57-75 WELLINGTON ROAD &
60-68 HIGH STREET

**TRANSPORTATION IMPACT
ASSESSMENT - ADDENDUM #1**

To: Mr. Michael Nemanic (Nemanic Law PC/Foundation Capital)
From: Michael Dworczak, P.Eng., (MDT Urban Traffic Solutions Ltd.)
Date: August 13, 2026
Project: 57-75 Wellington Road (Phase 1 – Wellington Tower) and 60-68 High Street (Phase 2 – High Tower), London, Ontario
Subject: Transportation Impact Assessment Addendum #1 – Revised Site Plan Statistics
City Files: SPC-26042 (Phase 1) and SPC-26043 (Phase 2)

Figure 1 – Revised Phase 1 and Phase 2 Site Layout Incorporating PUDO Lay-by Spaces

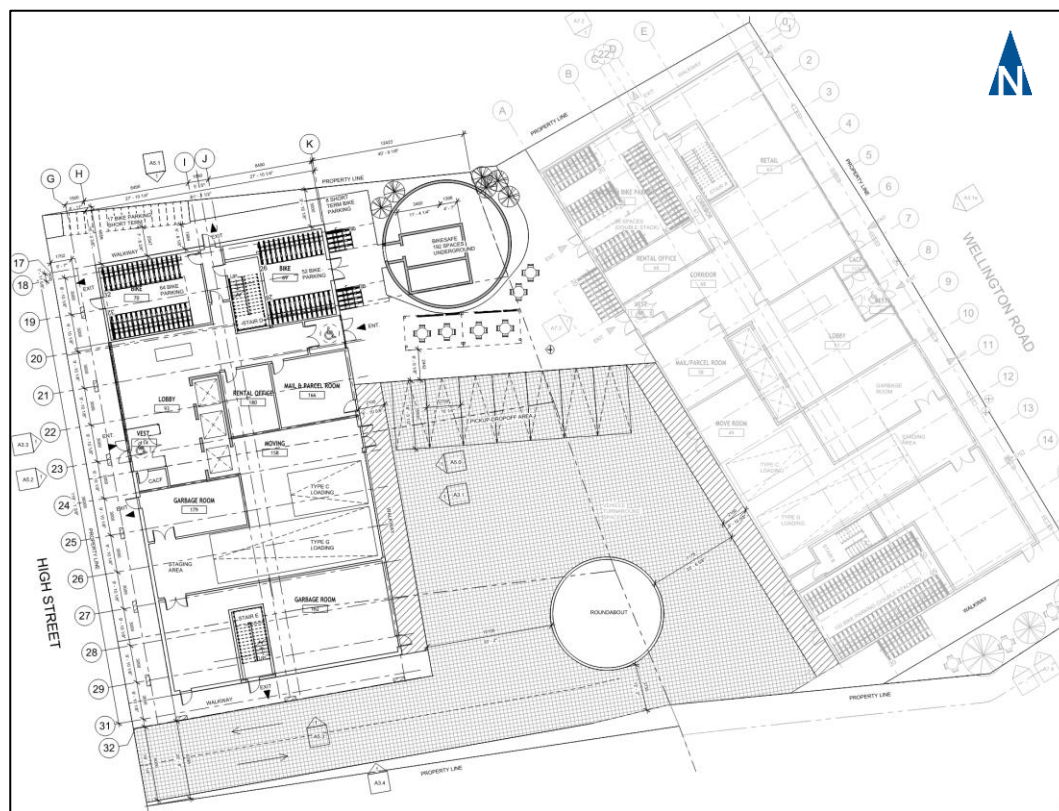
The original assessment identified a combined peak concurrent pick-up/drop-off (PUDO) demand of approximately 5 vehicles across the two phases, comprising approximately 3 vehicles for Phase 1 and 2 vehicles for Phase 2, and recommended that provision be made for between 3 and 5 short-term PUDO spaces within the internal circulation system. No at-grade PUDO spaces were provided in the concepts assessed at that time. The space released within the internal roundabout by the removal of the fire apparatus turning requirement has been used to revise the at-grade layout to incorporate additional spaces. The revised layout accommodates up to 7 at-grade spaces configured as lay-bys serving PUDO and passenger loading activity across the combined development. These proposed spaces are sized as per City of London By-law requirements at 2.7 metres wide by 5.5 metres in depth.

Figure 1 illustrates the revised at-grade site plan layout incorporating the PUDO lay-by spaces. The full site plan drawing can be found in **Appendix C**.

The revised provision of 7 spaces exceeds the 3 to 5 spaces recommended in the Phase 2 TIA for High Tower and represents a substantial improvement over the concepts previously reviewed, which provided no available parking/lay-by at grade. The recommendation of the original assessments is therefore satisfied in full, and PUDO activity is expected to be accommodated wholly on site without recourse to curbside stopping on High Street or Wellington Road. Provision of the lay-by spaces also addresses the Site Plan Control By-law requirements raised through SPC-26042 and SPC-26043 in respect of dimensioned lay-by provision.
